# UNITED STATES PATENT AND TRADEMARK OFFICE

APPLICATION NO.	FILING DATE	FIRST NAMED INVENTOR	ATTORNEY DOCKET NO.	CONFIRMATION NO.
10/814,246	04/01/2004	Takahiro Okuno	251363US2	6970
22850	7590	01/10/2006	EXAMINER	
OBLON, SPIVAK, MCCLELLAND, MAIER & NEUSTADT, P.C. 1940 DUKE STREET ALEXANDRIA, VA 22314				ARENA, ANDREW OWENS
			ART UNIT	PAPER NUMBER
			2811

<b>Office Action Summary</b>	<b>Application No.</b>	<b>Applicant(s)</b>	
	10/814,246	OKUNO ET AL.	
	<b>Examiner</b>	<b>Art Unit</b>	
	Andrew O. Arena	2811

## DETAILED ACTION

FIG. 13

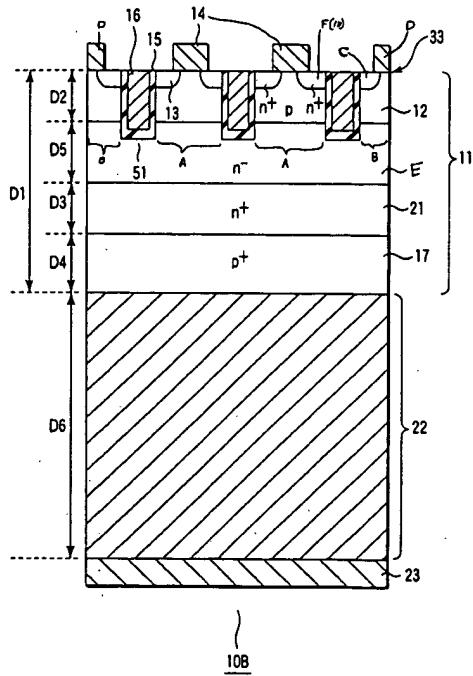
2. Claims 1-4, 6, and 8-12 are rejected under 35 U.S.C. 102(b) as being anticipated by Tanaka (US Pub. No. 2003/0042525), hereinafter Tanaka.
3. A copy of Fig. 13 from Tanaka is provided with additional references to clarify comparisons made by the examiner. The figure is identical to the original figure from Tanaka, with the exception that six new reference labels have been added.

4. Regarding claims 1 and 8, Tanaka discloses (Fig 13) a semiconductor device comprising:

- a drift layer (E) of a first conductivity type;
- a collector layer (17) of a second conductivity type located on the drift layer;
- a collector electrode (22,23) located on the collector layer;

- a base layer (12) of the second conductivity type located in a region isolated from the collector layer on the drift layer;
- a plurality of trenches (51) formed at certain intervals to extend from the top surface of the base layer into the drift layer and thereby divide the base layer to main cell regions (A) and dummy cell regions (B);

- a first emitter layer (F, 13) of the first conductivity type selectively formed in the surface layer of the base layer in each main cell region to extend along adjacent one of the trenches;

- gate electrodes (16) formed in the trenches sandwiching each main cell region among said plurality of trenches via a gate insulating film (15);
- an emitter electrode (14) located over the base layer and the first emitter layer in each main cell region; and

- a second emitter layer (C) of the first conductivity type selectively formed so as to be scattered in the surface layer of the base layer in each dummy region and having a surface area smaller than that of the first emitter layer (Note that Fig. 13 clearly shows second emitter layer (C) smaller than first emitter (F). With respect to this comparison,

drawings may not be interpreted as providing exact dimensions, but may be interpreted to indicate relative sizes).

9. Regarding claims 6 and 11, Tanaka discloses (Fig 13) a via contact (D) formed in contact with the second emitter layer (C) to connect the base layer (12) in the dummy cell region (B) to the emitter electrode (14) via the second emitter layer."

12. Regarding claims 5 and 13, Tanaka discloses (Fig 13) the semiconductor devices having the second emitter layer (D) formed as patterns in contact with the trenches (51) opposed to each other via the base layer in each dummy cell region. Tanaka differs from the claimed invention only in not expressly disclosing "the second emitter layer is formed as island shaped patterns each having opposite ends in contact with the trenches." However, such difference is regarded as nothing more than an obvious variation of Tanaka. Therefore, it would have been obvious to a person of ordinary skill in the art at the time the invention was made to connect the isolated second emitter regions opposing one another in each dummy cell region to one another, forming a continuous island-pattern second emitter region with opposite ends in contact with the trenches opposed to each other; at least for enhanced electrical effect of second emitter region, enlarging the second emitter region.

17. Examiner does not concur that "Tanaka fails to disclose or obviate" the common fundamental feature of Claims 1 and 8 "that a base layer of the second conductivity type is divided into main cell regions and dummy cell regions." Nothing in the claims and no submitted evidence precludes the labeling of main (A) and dummy (B) cell regions in Fig 13 of Tanaka. The claims fail to structurally distinguish over the cited art.
